Discovery Point, Wollie Creek

Discovery Point, Woll Creek Concept Plan

Building 8 Envelope Parameters

Scale	1:250 @ A1 , 1:500 @ A3		
Drawn	AW	Checked	MA
Project no.	S11191		
Status	PLANNING		
Plot Date	3/06/2013 4:49:26 PM		
Plot File	C:\Temp\masterplan-discovery-111110_Central_WAY.rvt		
Drawing no.	DA3-010	Revision	F

4 3D View
DA3-012

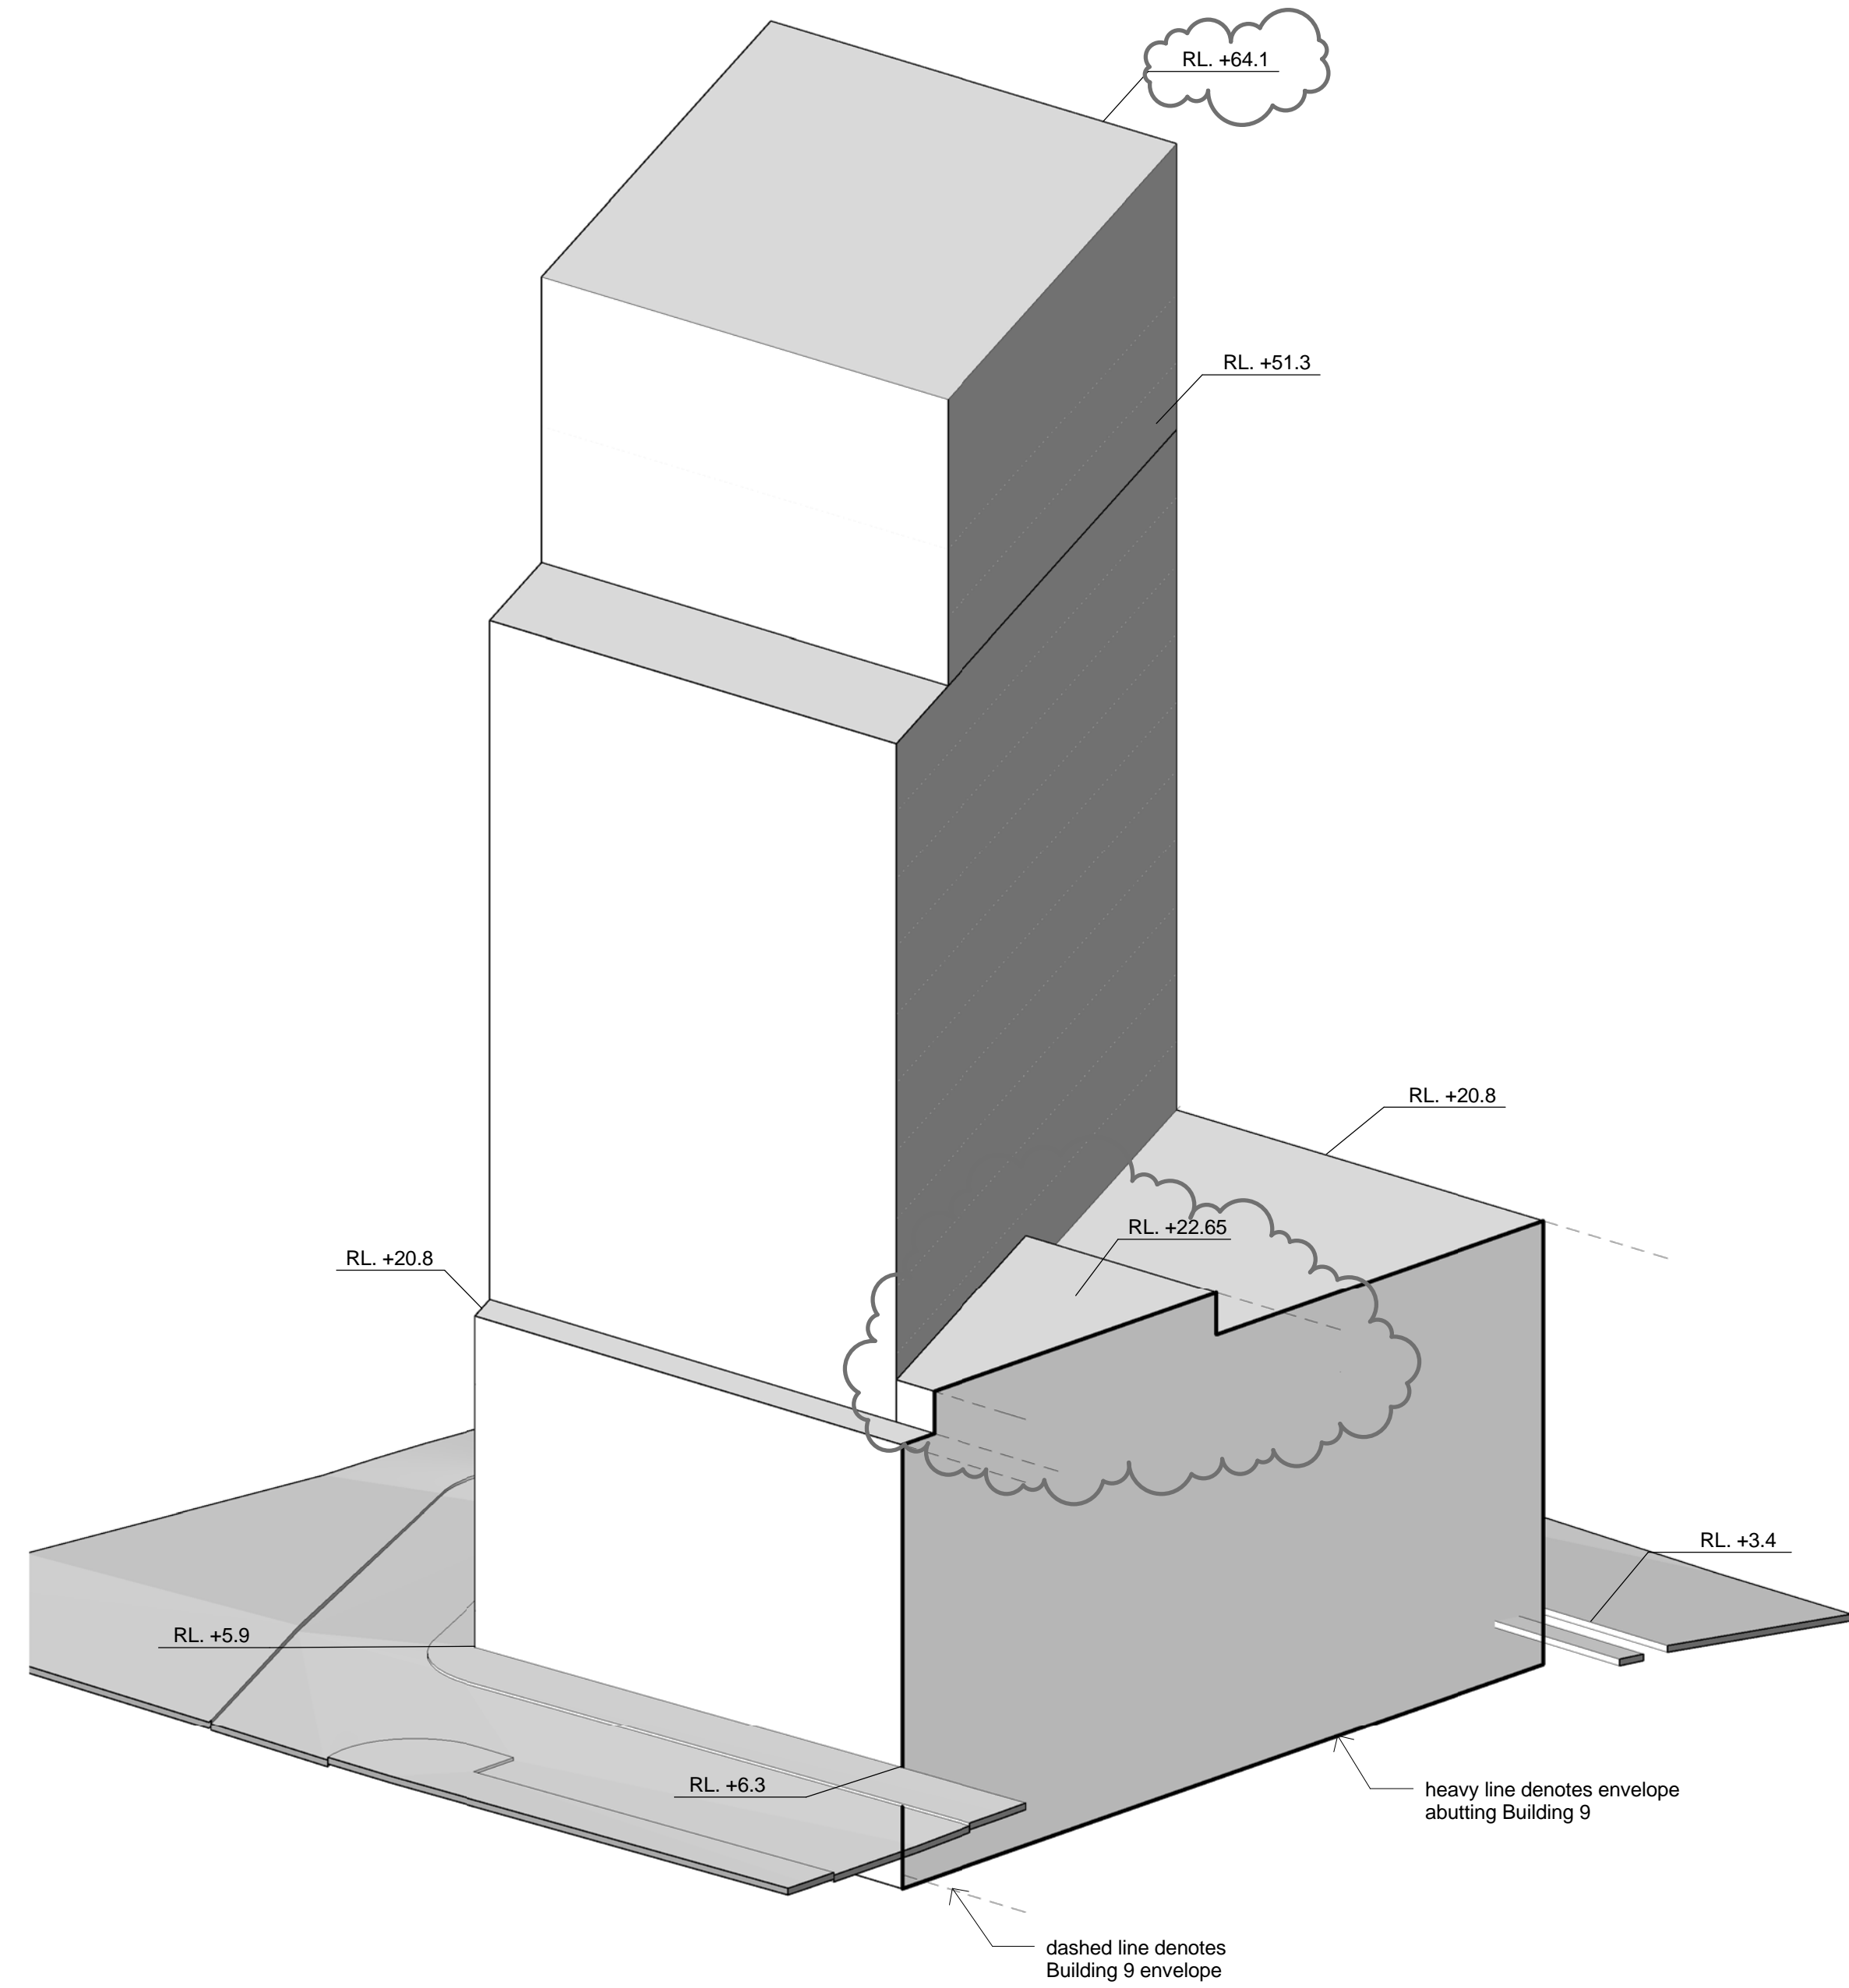
Amendments since Revision A
Envelope reduced at South and East to increase building separation
Setback to Cooks River Increased
